STATE OF NORTH CAROLINA  
DEPARTMENT OF TRANSPORTATION

Subject: **REVISION to Application for Individual Section 404 Permit and 401 Certification** for the widening of US 321 from SR 1500 (Blackberry Road) to US 221 at Blowing Rock; Watauga and Caldwell Counties; State Project No. 6.739001T; NCDOT Division 11; TIP No. R-2237C, WBS Element No. 34402.2.6

This Application Revision is being submitted to augment the previously submitted application referenced above. This Revision includes responses to comments received in letters from the DWQ and from the USACE, as referenced above, and corrections/clarifications to the original application. This Revision application package consists of the cover letter, attachments for the responses to the USACE comments, a revised EEP acceptance letter, and Revised Permit Drawing Sheets (including revised Wetland Permit Impact Summary sheets) along with the applicable corresponding revised roadway plan sheets.

REVISED 10-5-10  
Permit Drawing  
Sheet 35 of 45

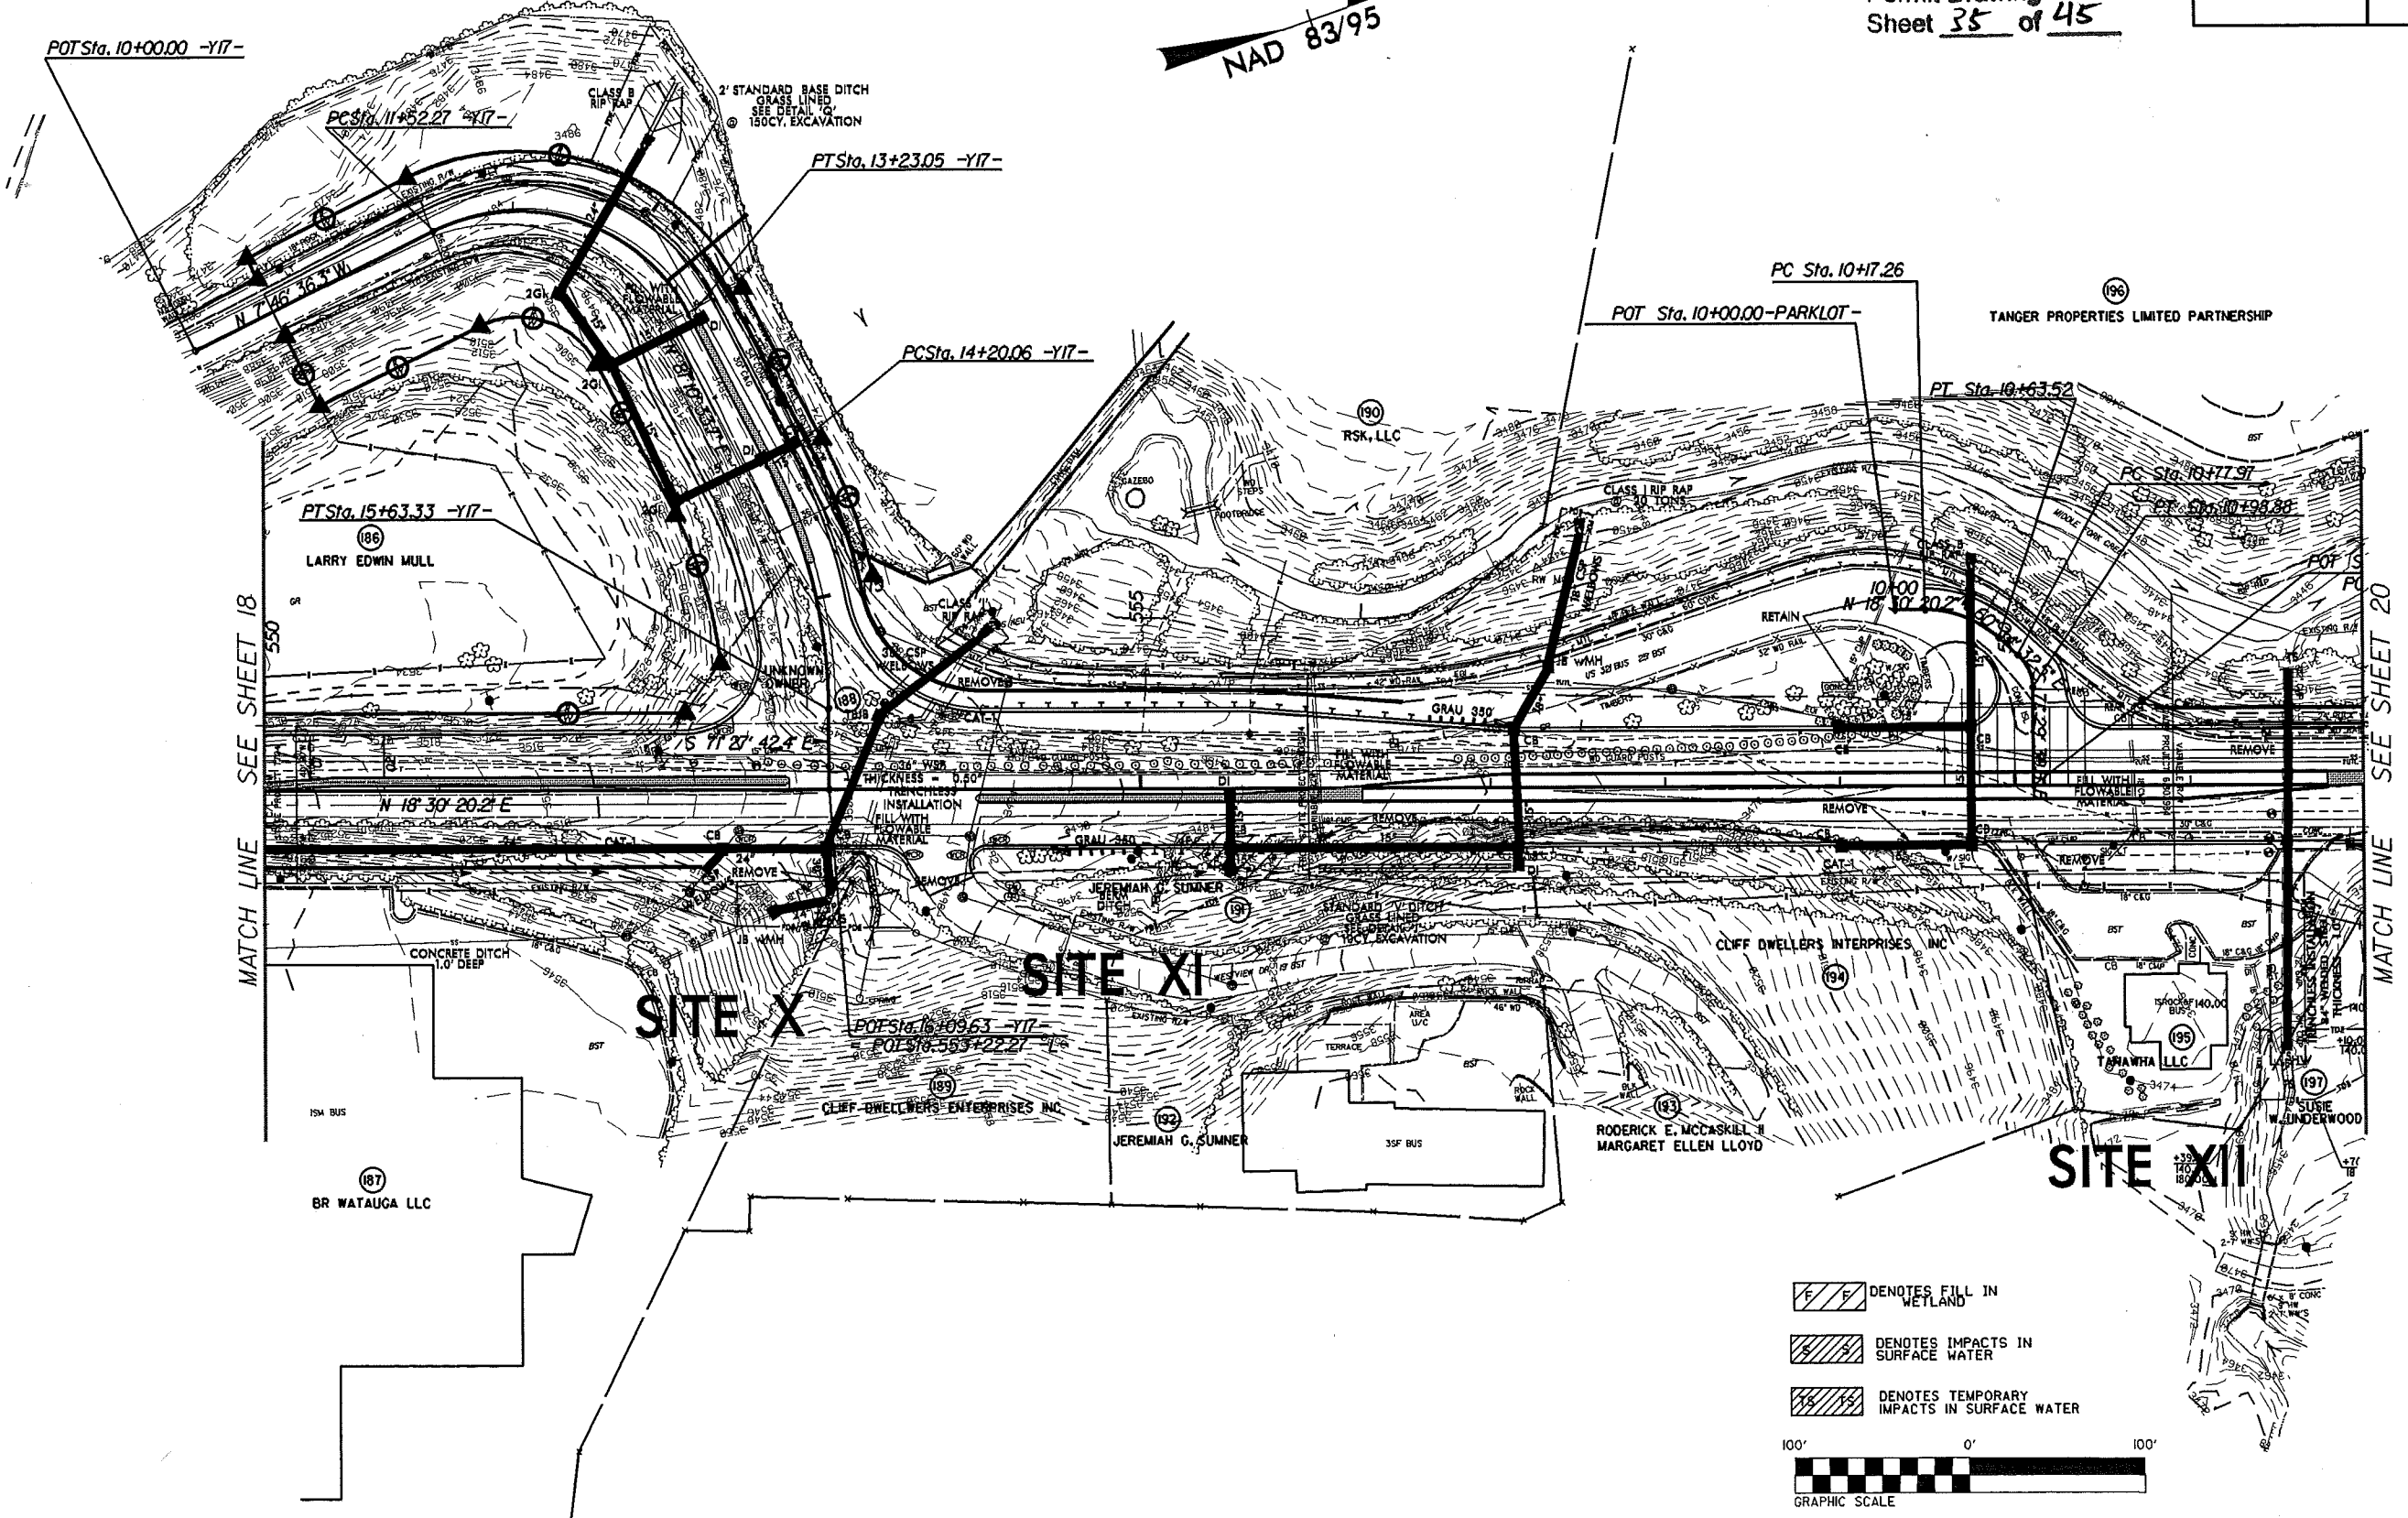
At Site X in the original application submittal, UT3 to Middle Fork Creek was proposed to be piped to the stormwater system. The impacts at this site did not include impacts that would have occurred to the downgradient segment of UT3 to Middle Fork Creek located between US 321 Business and Middle Fork Creek (this segment of UT3 to Middle Fork Creek was not included on the design plans). Due to the grade at the pipe outlet on the west side of US 321 Business, riprap is proposed to be placed in the stream channel to reduce erosion, resulting in a net increase of 10 lf of permanent stream impacts to UT3 Middle Fork Creek (Note: 98 lf of stream impacts were avoided). See Revised Permit Drawing Sheets 34-36 of 45, and the applicable corresponding revised roadway plan sheet number 19. The revisions at Site X are summarized below (and presented in revised Table 4 of this application):

- UT3 to Middle Fork: 59 lf (revised from 49 lf)
  - UT4 to Middle Fork: 25 lf (unchanged)
- Total for Site X = 84 lf (revised from 74 lf)

PROJECT REFERENCE NO.	SHEET NO.
R-2237C	II
RW SHEET NO.	HYDRAULICS ENGINEER
ROADWAY DESIGN ENGINEER

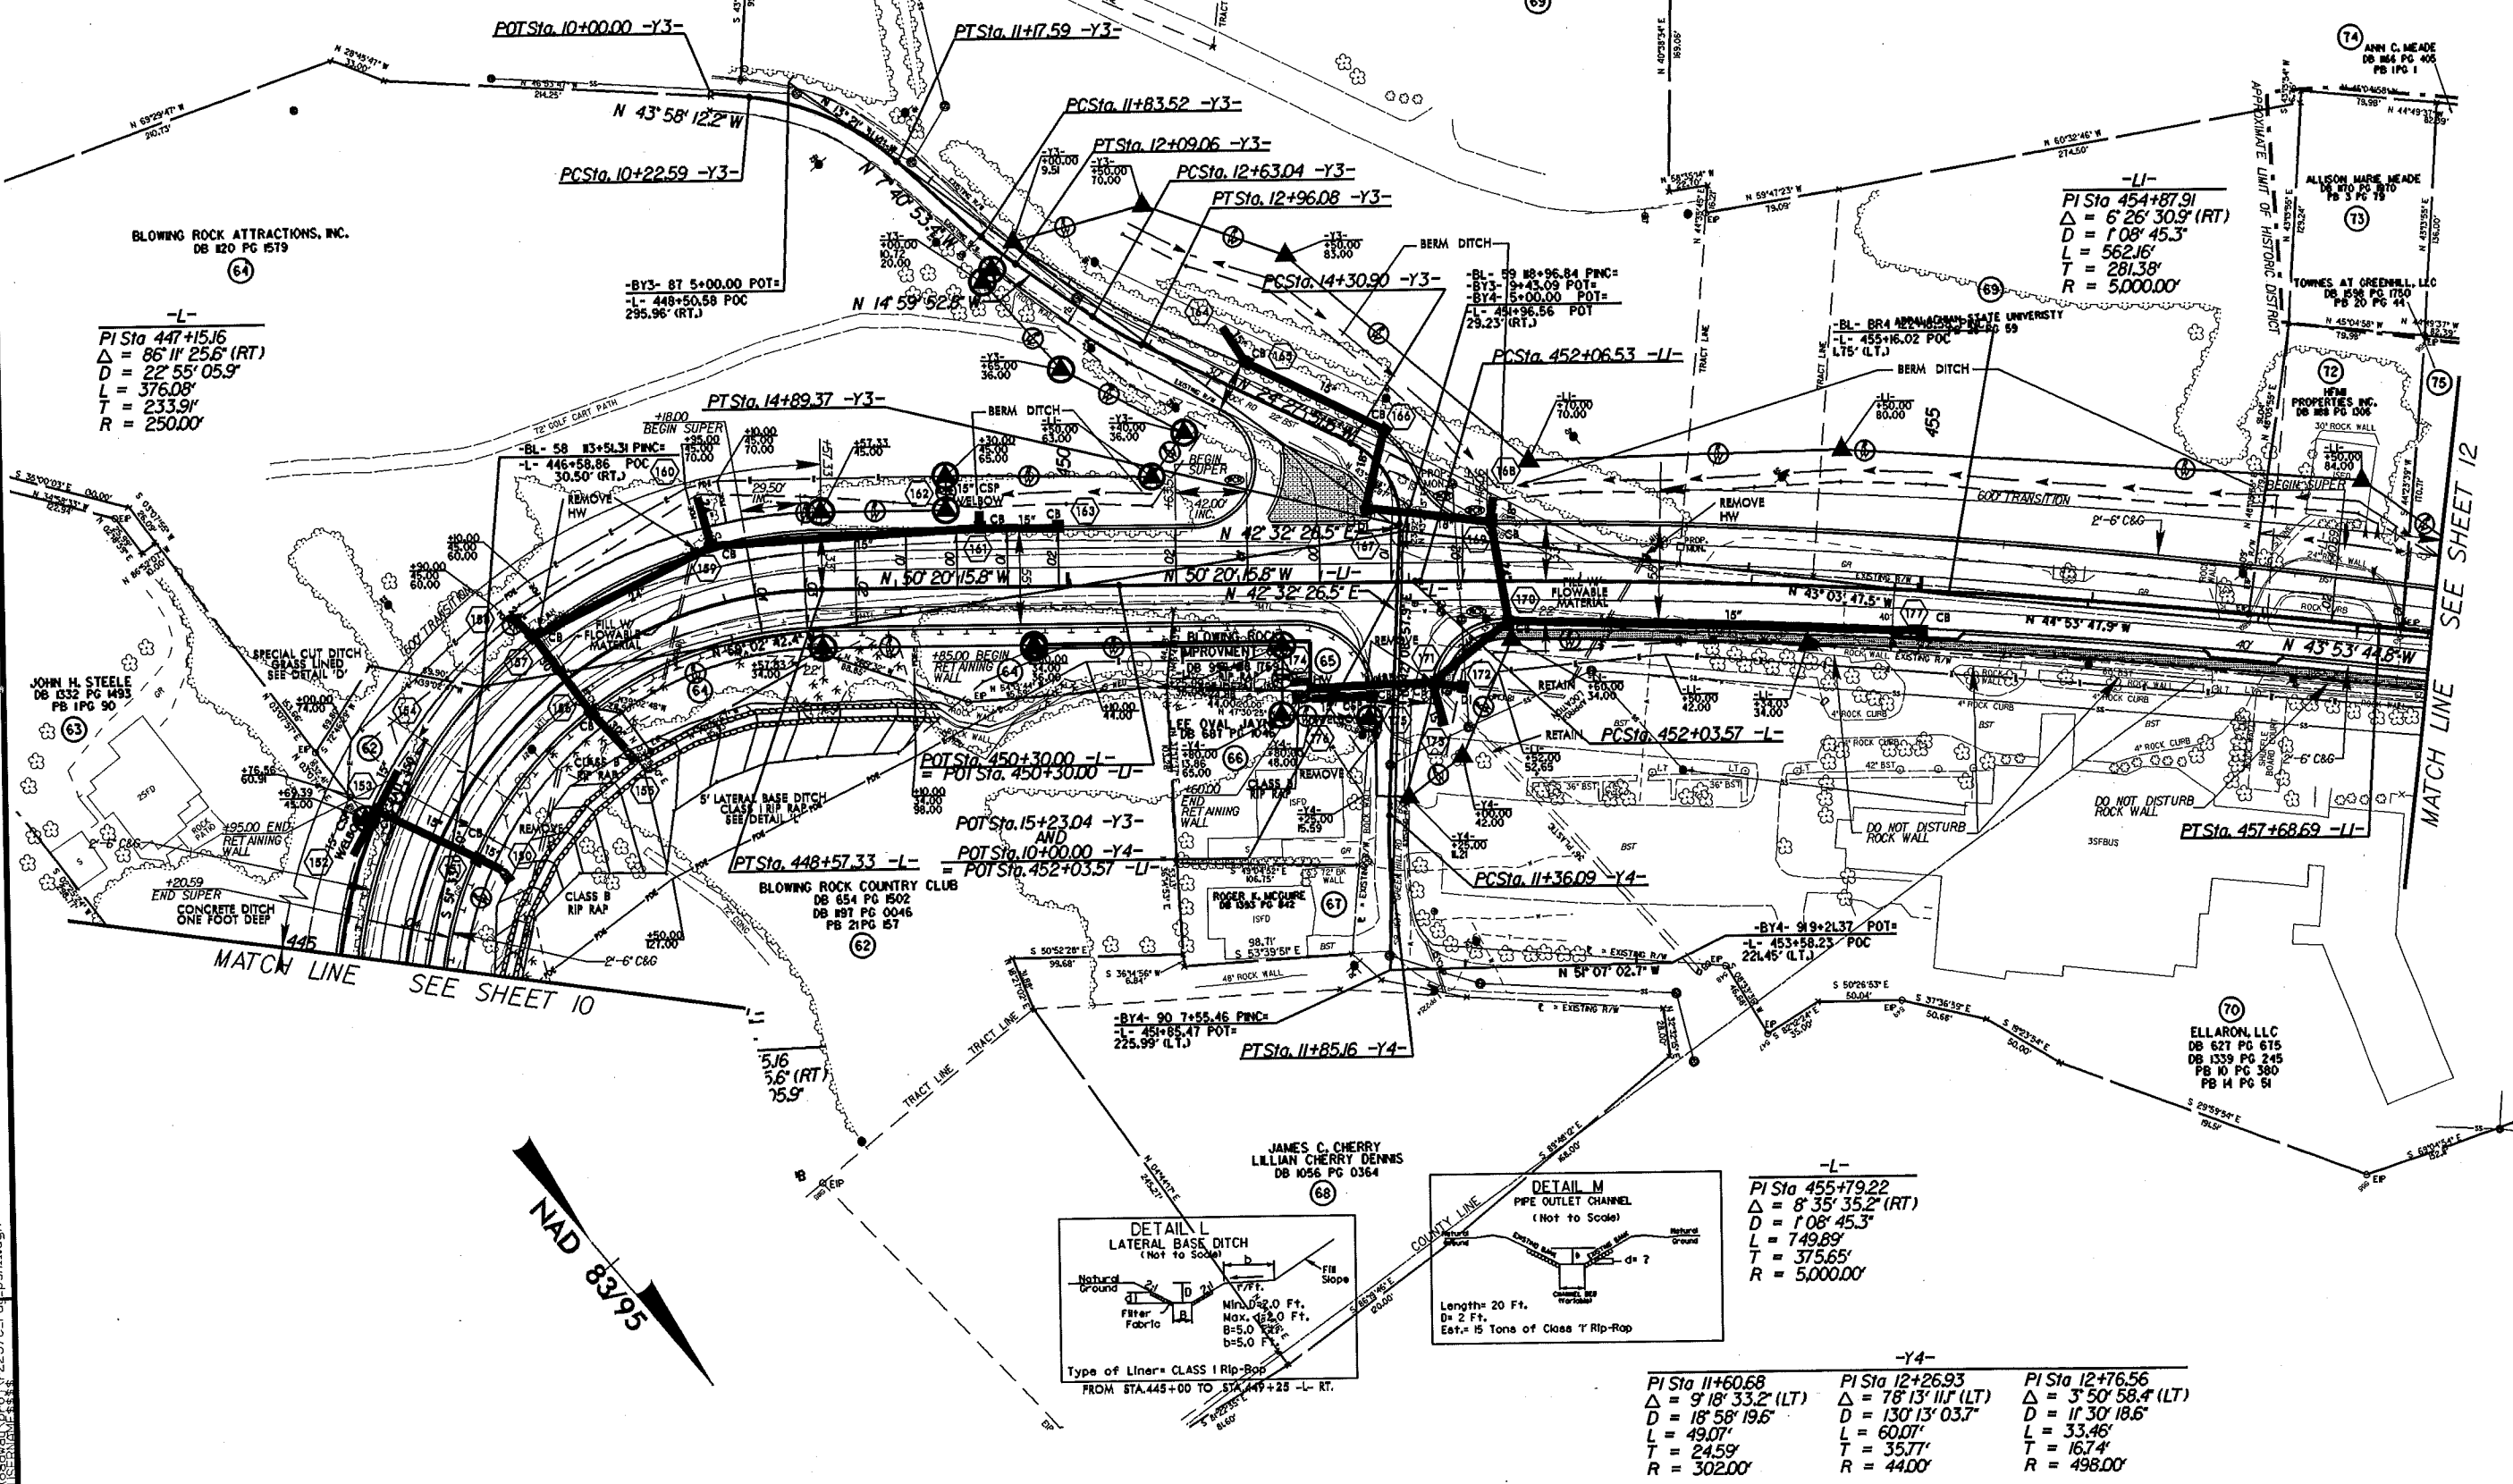
The permit drawings for Site IV have been revised to depict the existing stream connecting directly to the relocated portion of the stream. On the original drawings, there was a disconnect between the two sections of stream. See Revised Permit Drawing Sheets 12-14 of 45 and the applicable corresponding revised roadway plan sheet number 11. There is no change in impacts.
